MARK LEVINSON AUDIO SYSTEMS

TECHNICAL SERVICES
March 19, 1982

RE : Buzz Circuits

ML-2 REBUILD INSTRUCTIONS

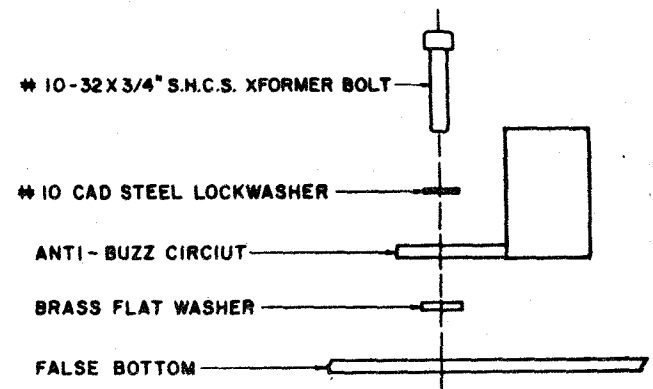
ML-2 ANTI-BUZZ CIRCUIT REMOVAL (ORIGINAL TYPE)
(Refer to diagram)

- 1) Disconnect all cables from the amplifier.
- 2) Remove the top and bottom plate (5/64 hex).
- 3) Remove wire A from the "line" terminal of the circuit breaker. Disconnect wire B from wire C.
- 4) Remove lower right hand transformer bolt securing present anti-buzz circuit. Do not reuse this bolt.
- 5) Remove present anti-buzz circuit.
- 6) Replace transformer bolt with 10-32 x 5/8" bolt supplied, in conjunction with the #10 cad steel lockwasher and brass flat washer.

HARDWARE FOR TOROIDAL TRANSFORMER MOUNTING IN MC-2

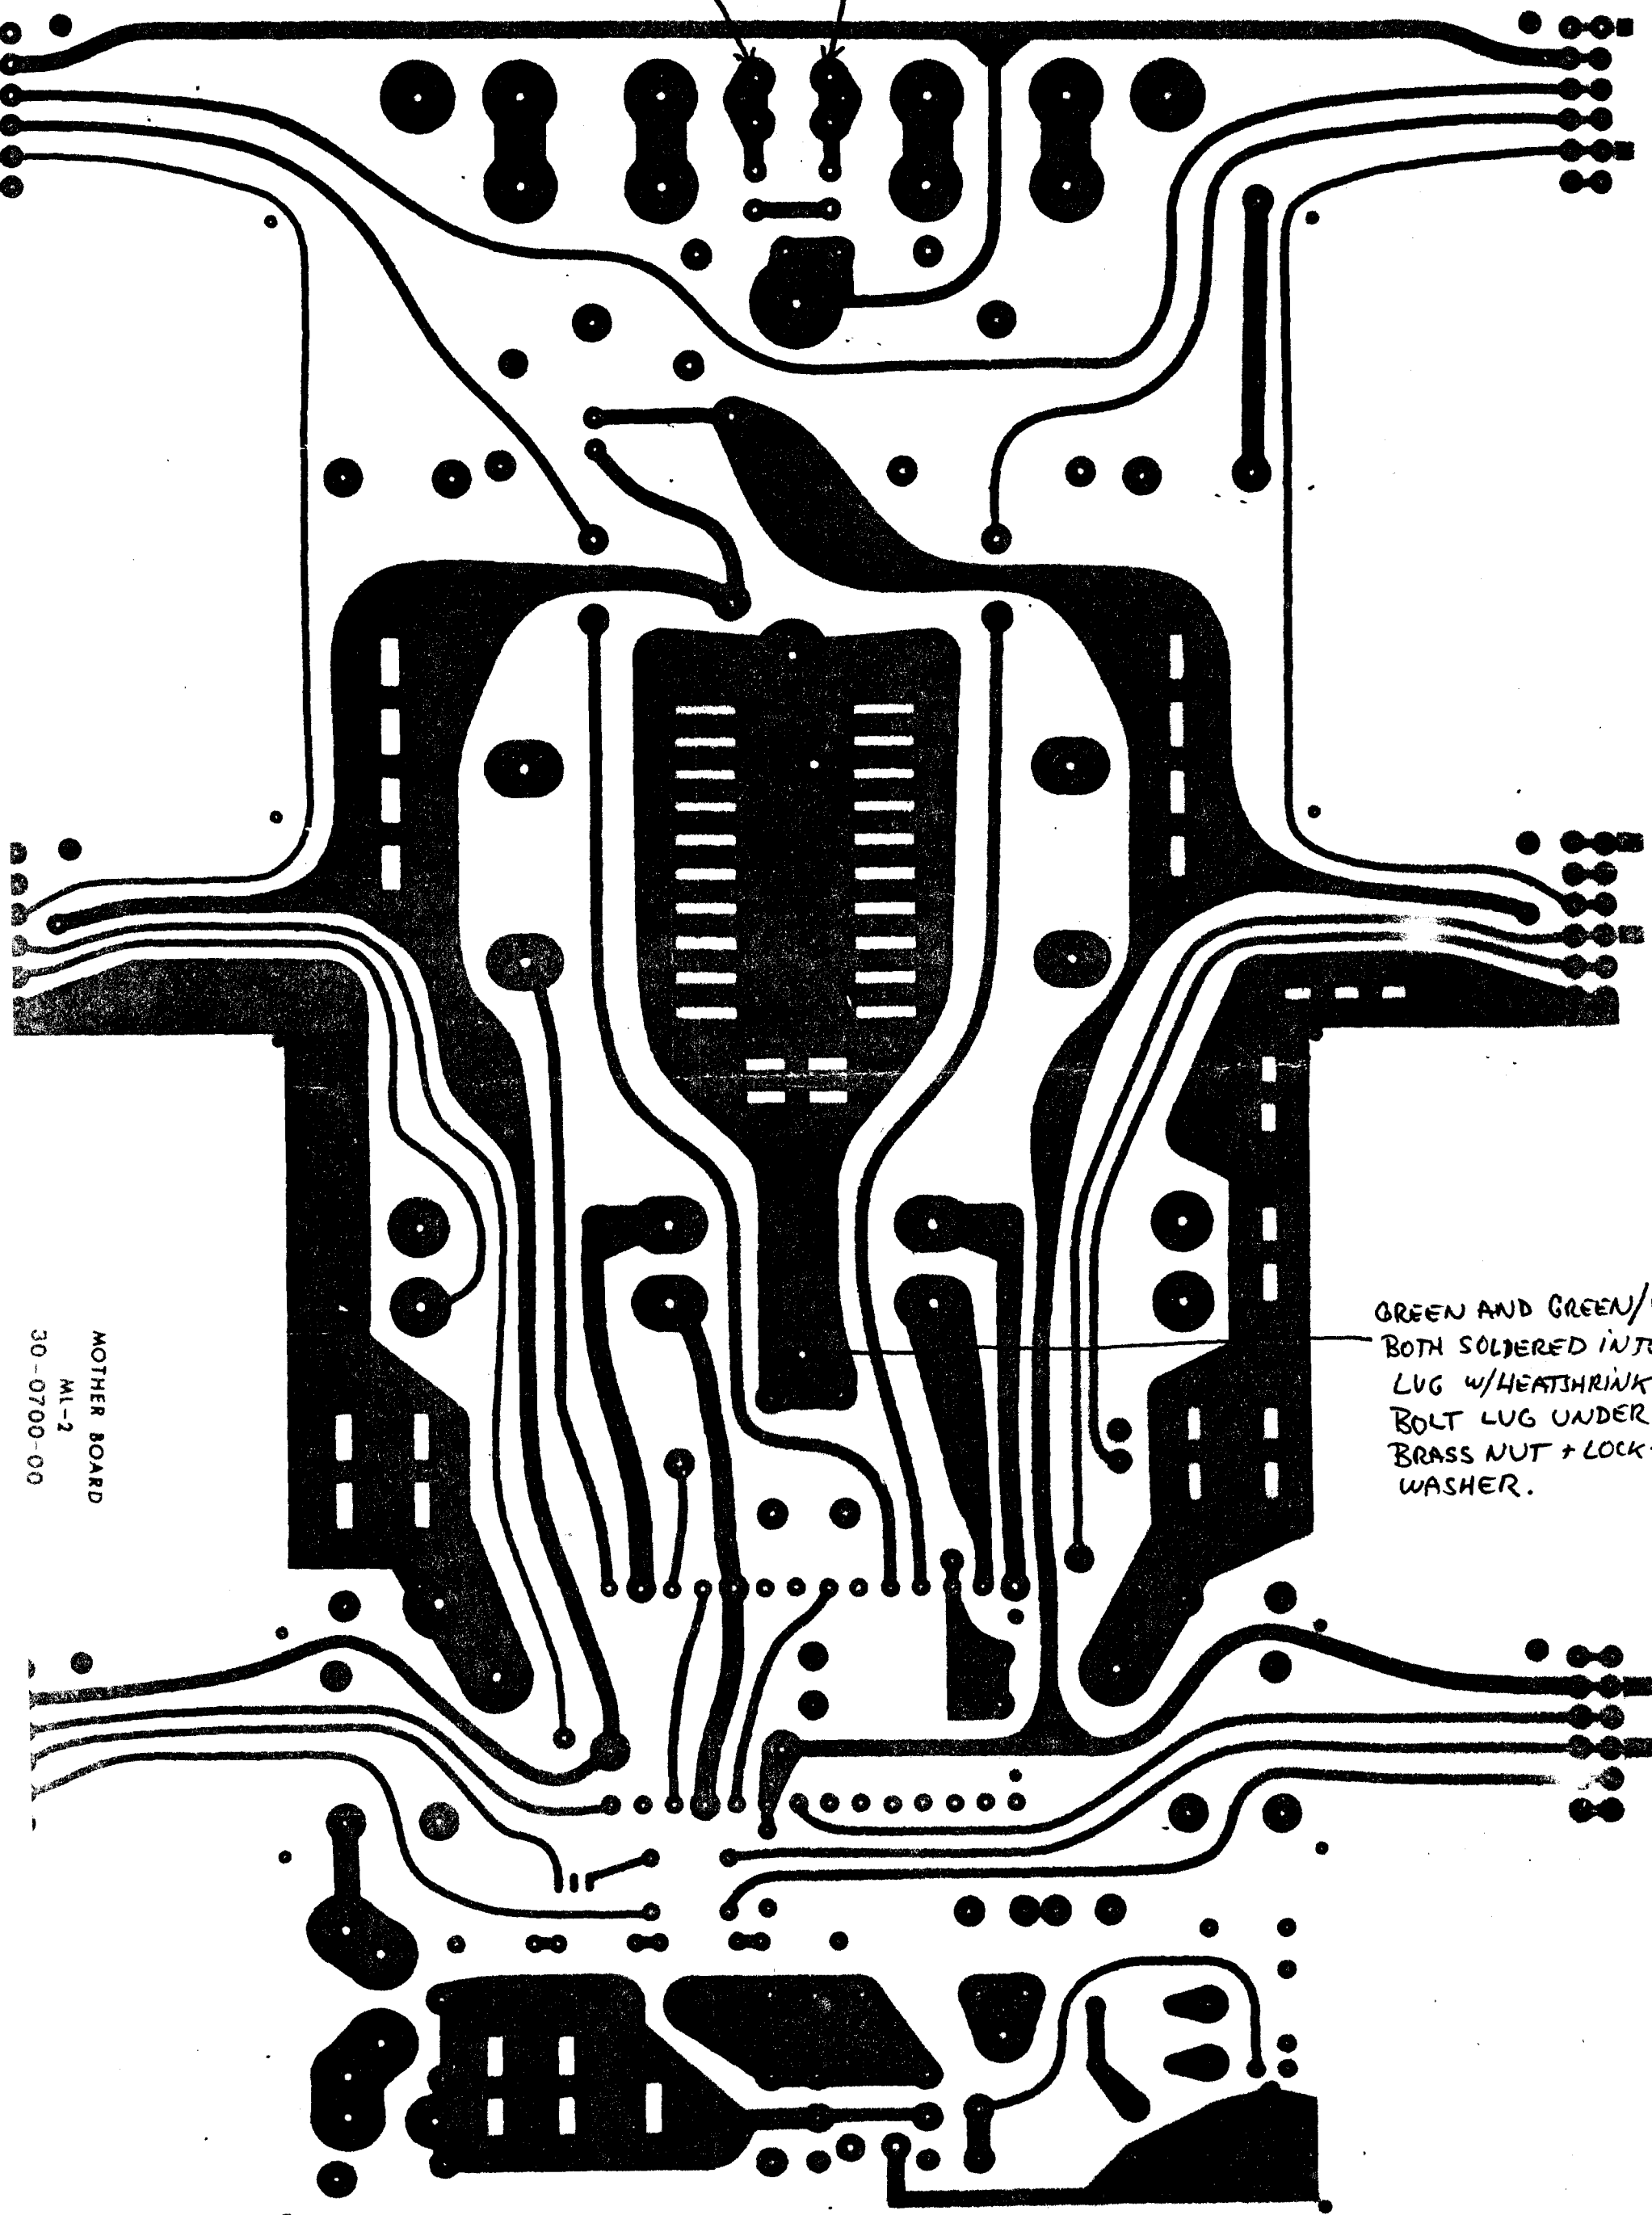
4pcs. 52-0009-00-S0-00 10-32 x $\frac{5}{8}$ " SHCS

4pcs. 52-0011-00-LW-00 #10 JTLW

4pcs. 52-0037-00-W0-00 BRASS FLAT WASHER

1pc. 47-3180-10-HS-00 HEATSHRINK BLACK 1"

1pc. 50-0600-00-HE-00 RING TERMINAL

ML-2 TRANSISTOR REPLACEMENT

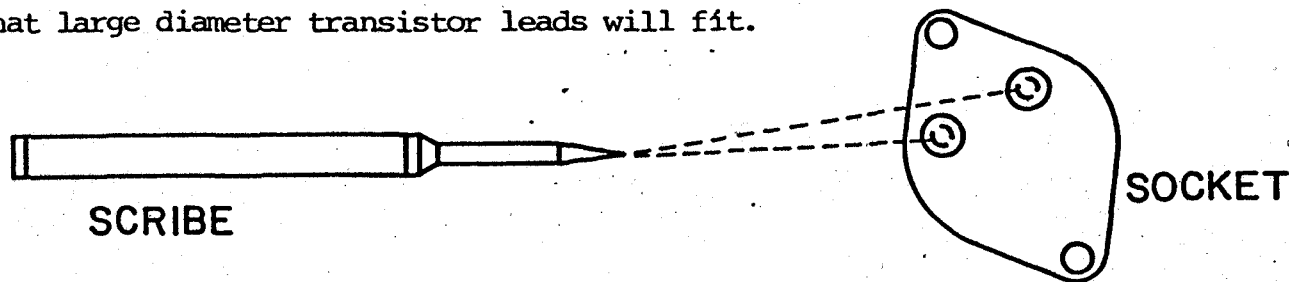
When 2N5684 and 2N5686 transistors are supplied, it will be necessary to trim the leads (as shown in diagram below) and to enlarge the socket openings in the heatsink.

Snipping the leads with a diagonal cutter will create a bevel on the end of the lead.

Using scribe like tool, spread transistor socket contacts so that large diameter transistor leads will fit.

MOTHER BOARD
ML-2
SOLDER SIDE

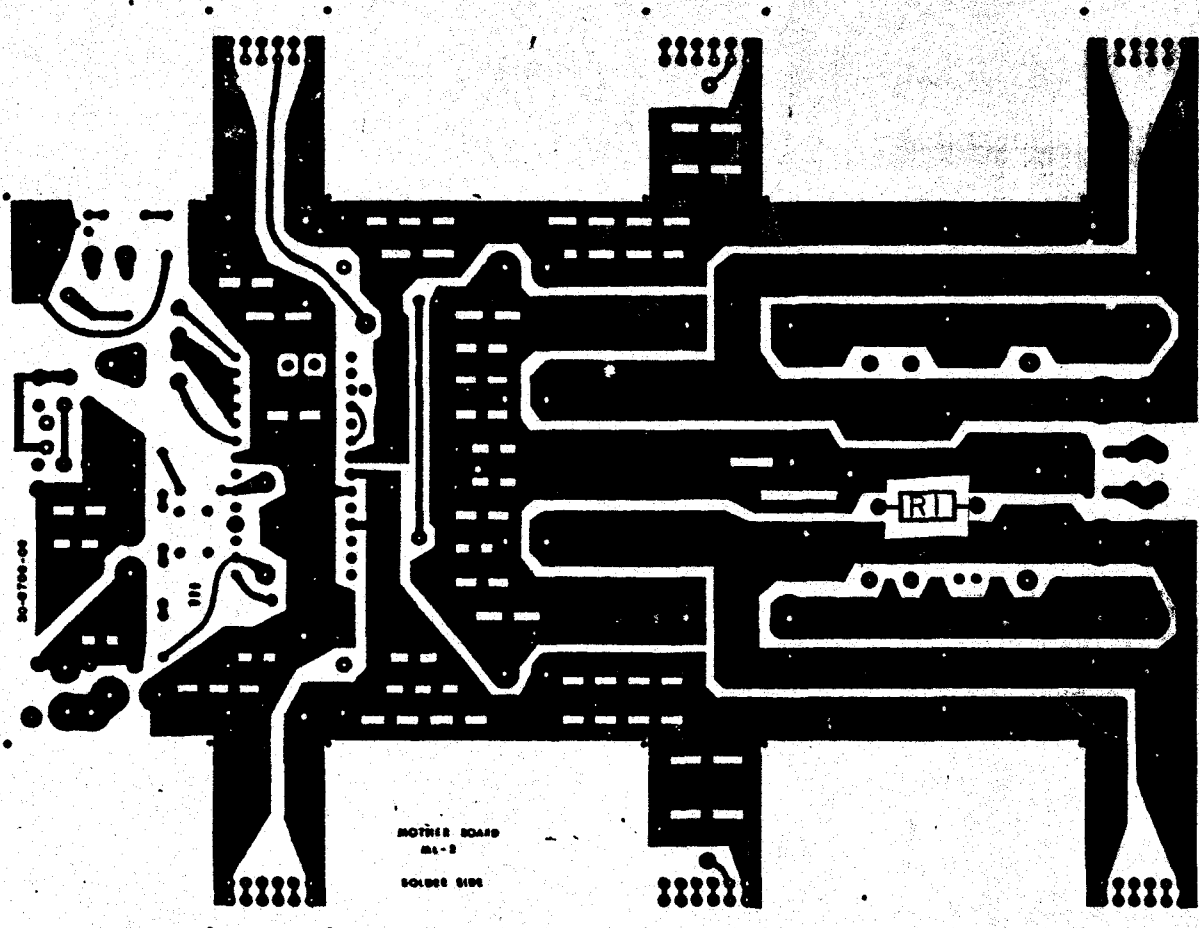
R1 SHOULD BE CHANGED TO 30 ohms or 33ohm /5W WHEN DRIVER TRANSISTORS MJE15030/MJE15031 MATCHED PAIR IS USED.
